# PERMIT

SEWAGE DISPOSAL SYSTEM  
HOWARD COUNTY HEALTH DEPARTMENT  
BUREAU OF ENVIRONMENTAL HEALTH  
410-313-2640

SUBDIVISION      LOT NUMBER 241 ADDRESS 685 West Watersville Road

PROPERTY OWNER Glenn Laycock PROPERTY OWNER'S ADDRESS 3776 Dorsey Search Circle

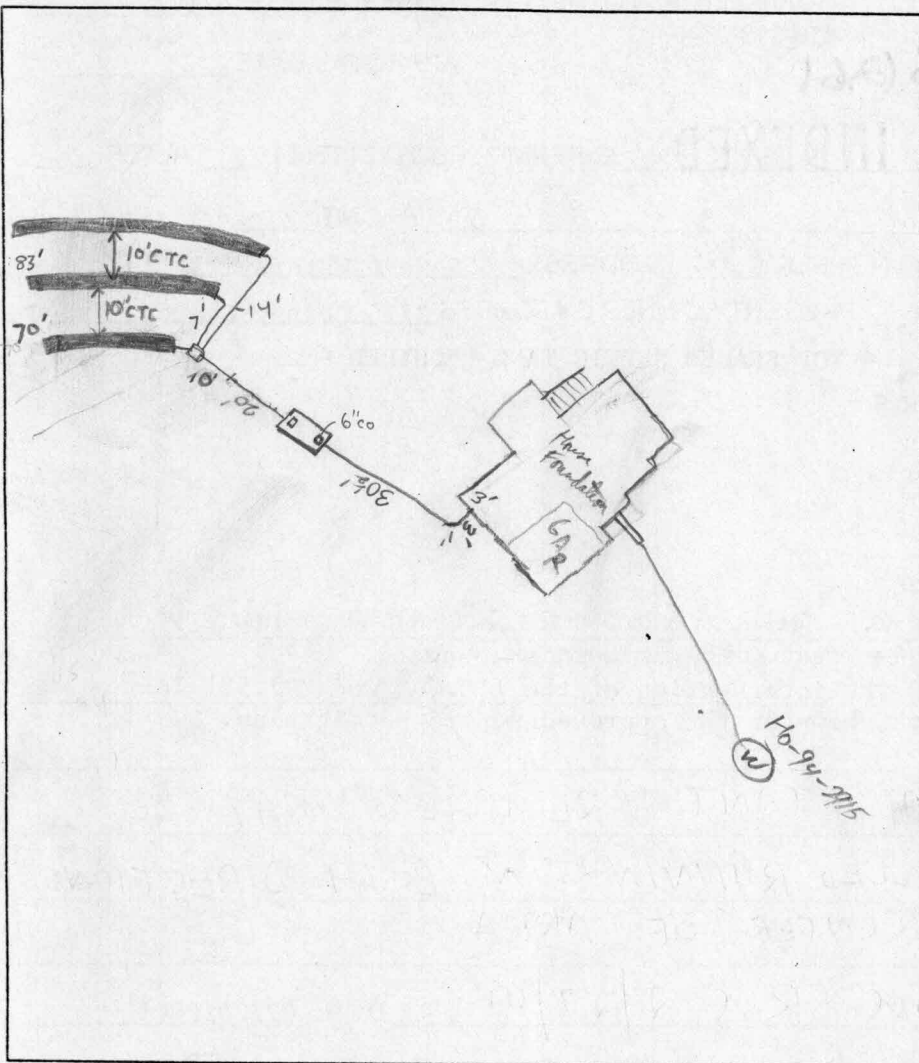
LAYOUT INSP. IMPORTANT, TRENCHES MAY BE  
BETTER INSTALLED RUNNING IN BOTH DIRECTIONS  
WITH BOX IN CENTER OF AREA

PRE-CONSTRUCTION INSPECTION: Plan calls for 70', 80', 90' respectively from dist box, layout is on center.  
6" Tr will be 70', if can get 2nd trench @ 100' long (possible) it's ok to place dist trench as a 50' long one uphill of 70'.

INSPECTION COMMENTS: Septic Tank + House Connection OK to cover to 20' past ST. Rpt. 4/20/01  
4/23/01 - ON TO COVER ALL WORK - (SRW)
